**Subject:** Part 1 - Petition NO. 1388 - 189 Boston Post Road Old Lyme, CT 876406/459664

## Modification Inspection Report

**Crown POC:** Dan Vadney  
3 Corporate Park Drive, Suite 101  
Clifton Park, NY 12065  
**BU Number:** 876406  
**Site Name:** Old Lyme Firehouse  
**Site Address:** 189 Boston Post Road, Old Lyme, CT 06371, USA  
**Latitude N 41° 20' 56.37", Longitude W 72° 17' 43.65"**  
**110 Foot** – Monopole Tower

# MODIFIED 110'-0" MONOPOLE RED LINE DRAWINGS BU #876406; NE OLD LYME-OLD LYME FIREHOUSE

**S-6**

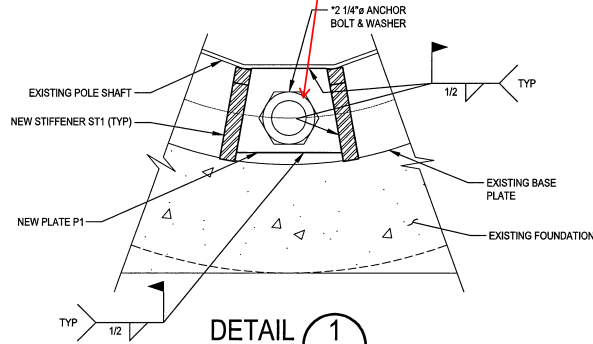
Due to the addition of the Doublers Plate 2 nuts will not fit. Jam nuts used

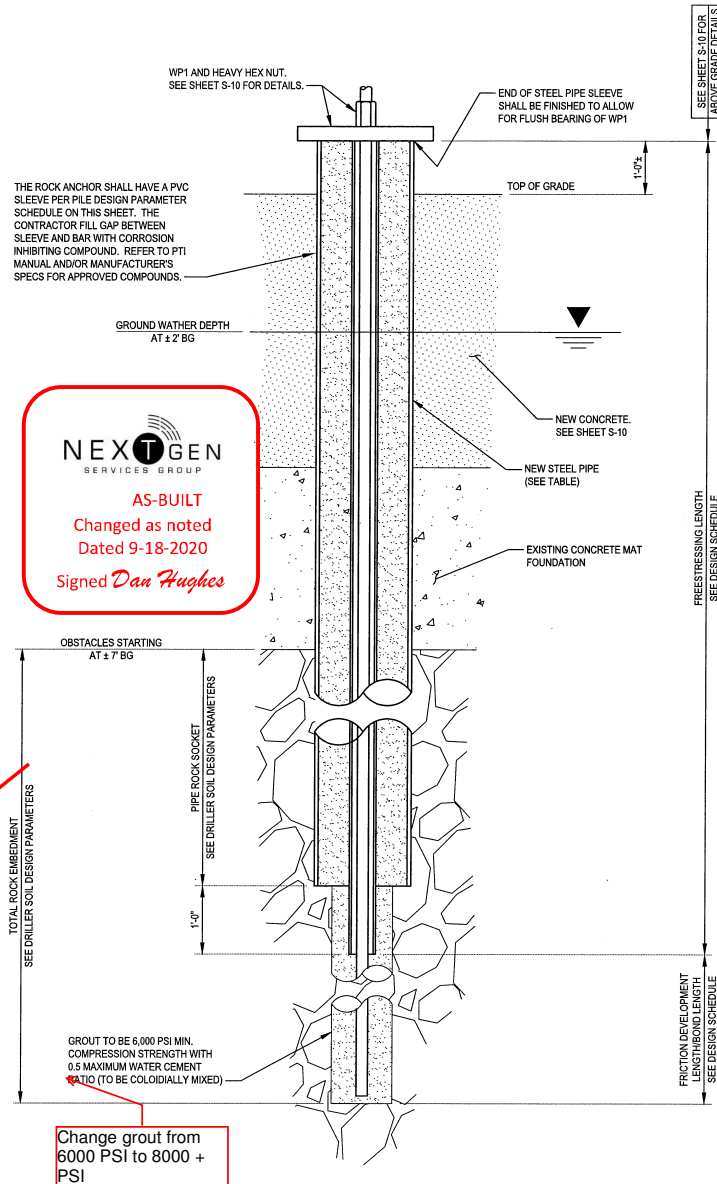
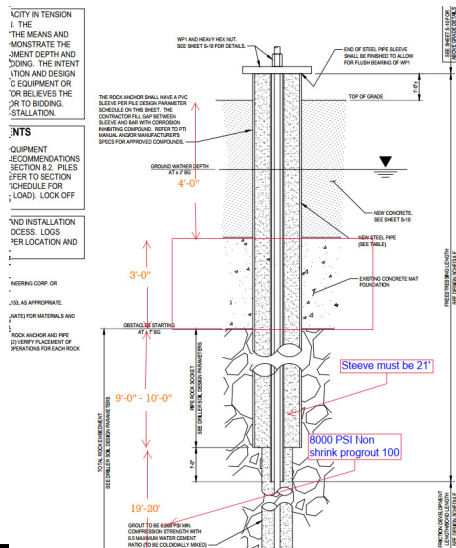
change from 3.5" OD anchor rod PVC sleeve to 4" ID PVC Sleeve

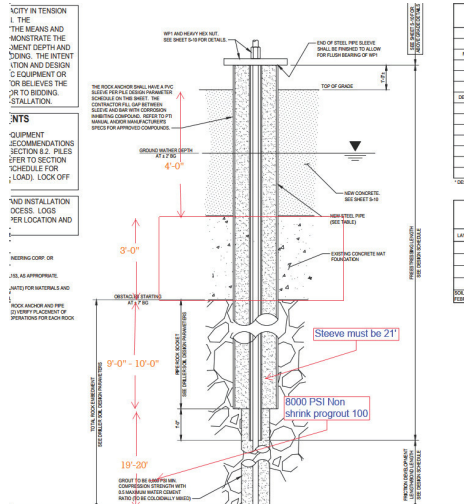
- 1) Request change from 3.5" OD anchor rod PVC sleeve to 4" ID PVC Sleeve
- 2) Change grout from 6000 PSI to 8000 + PSI
- 3) Dimensional changes
